ADMINISTRATIVE, VARIANCE OR MISCELLANEOUS APPEAL APPLICATION

Together with abutters and concerned townspeople, Sol and Alicia Dostilio (immediate abutters to the Deacon Hayes Commons Project), request relief from the decision to approve the final application of the Deacon Hayes Commons Major Subdivision, located in North Yarmouth Maine on an interpretive basis. The decision to approve the application was based on inaccurate interpretation by the Planning Board on September 13, 2022. The decision to approve the Deacon Hayes Commons Project is inconsistent with the North Yarmouth Land Use Ordinance. The request for relief from the decision to approve the final application for the Deacon Hayes Commons Major Subdivision should be granted because the project does not meet all required land use ordinances and will have an adverse effect on the abutters and community in its current state. The Planning Board failed to properly interpret and enforce the following specific land use ordinances.

SUBDIVISION PLAN DEACON HAYES COMMONS 527 WALNUT HILL ROAD - NORTH YARMOUTH MAINE OWNER OF RECORD 527 LLC 865 OAK HILL ROAD - NORTH YARMOUTH, ME	SJR ENGINEERING, INC. 16 THURSTON DRIVE NORTH YARMOUTH

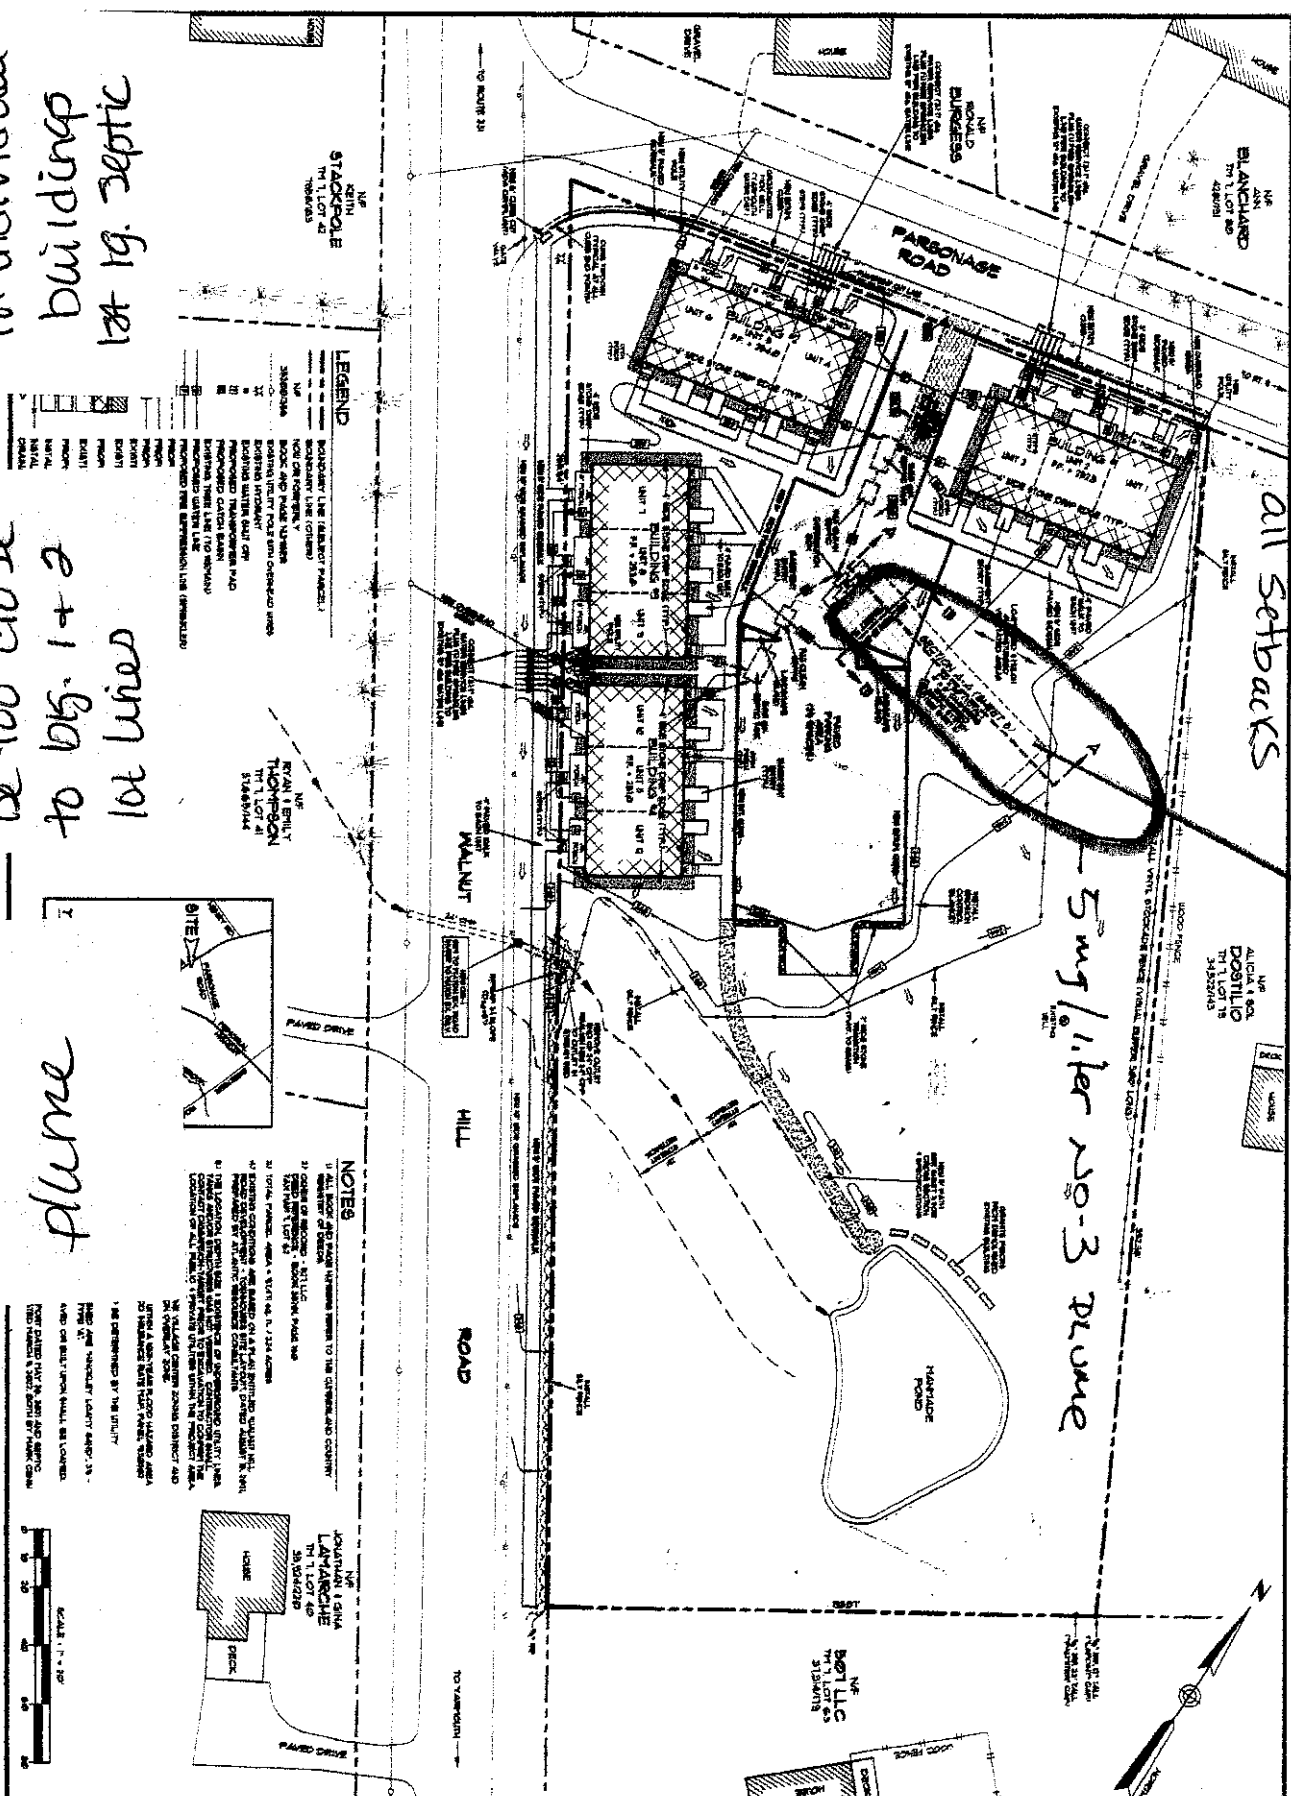
no lot lines
for individual
buildings
at 19. Septic

Septic could
be too close
to bldg. 1+2
lot lines

Shade
flume

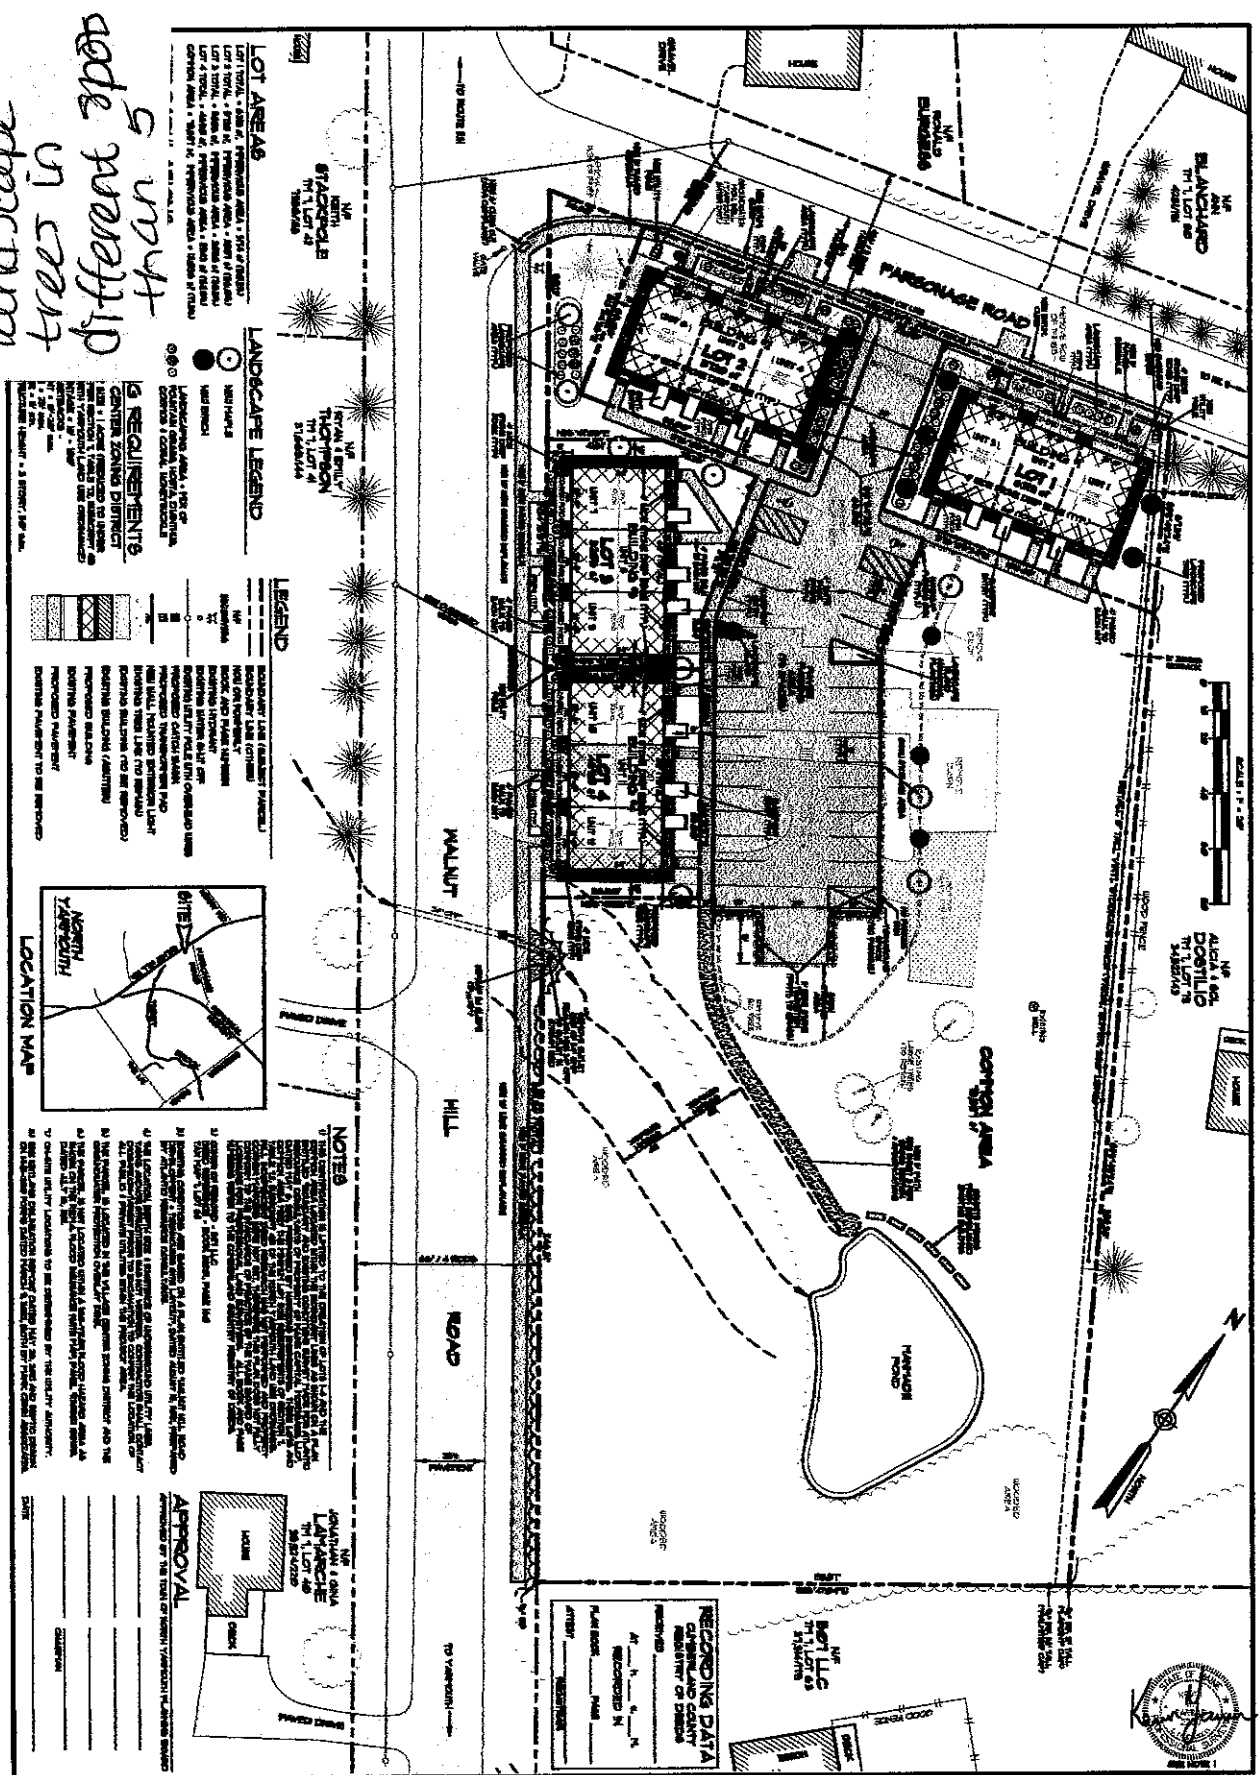
Handwritten: Landscape trees in different spots than 5

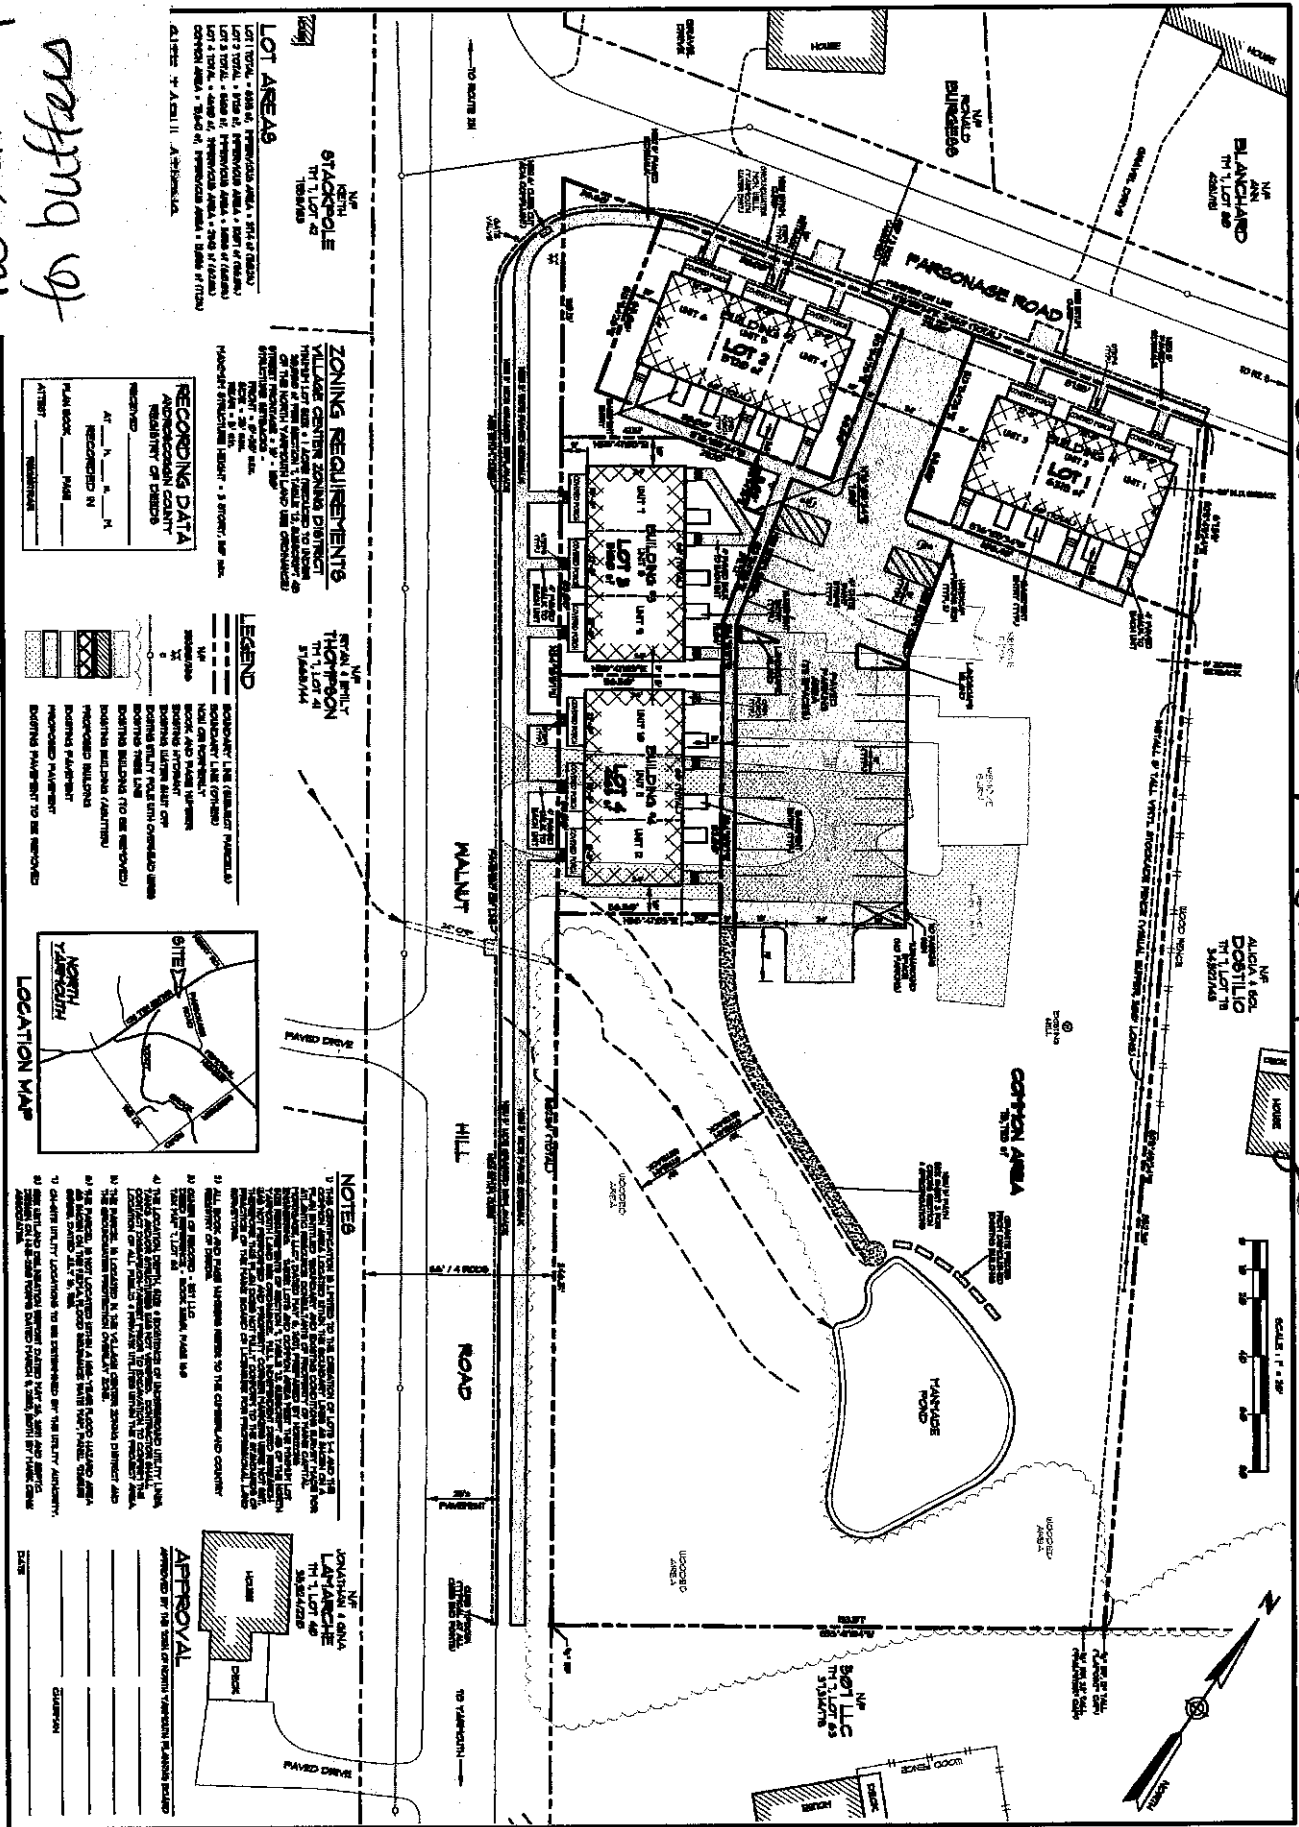
lot lines on landscape buffers of

lot line w/ No foliage

old sketch

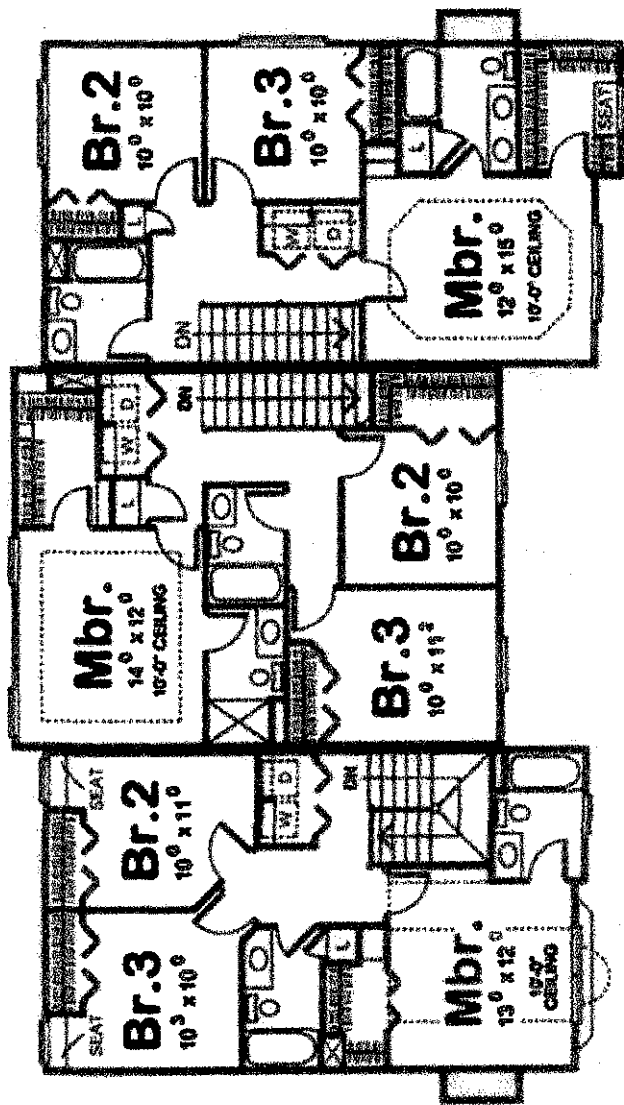
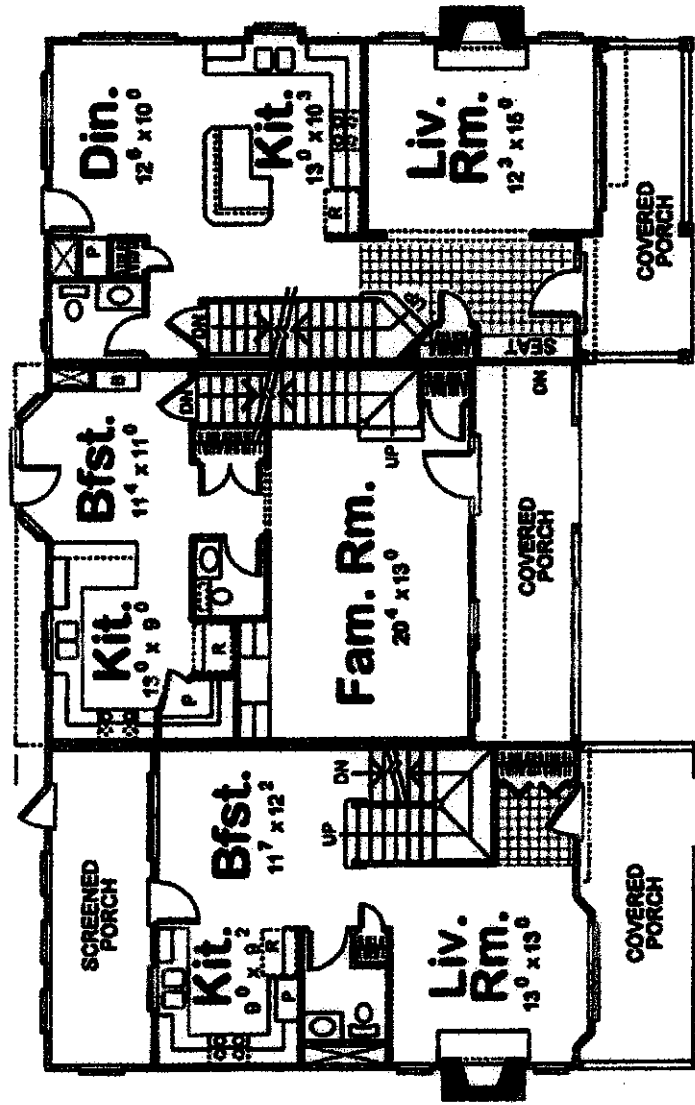
new lighting line
201
NO
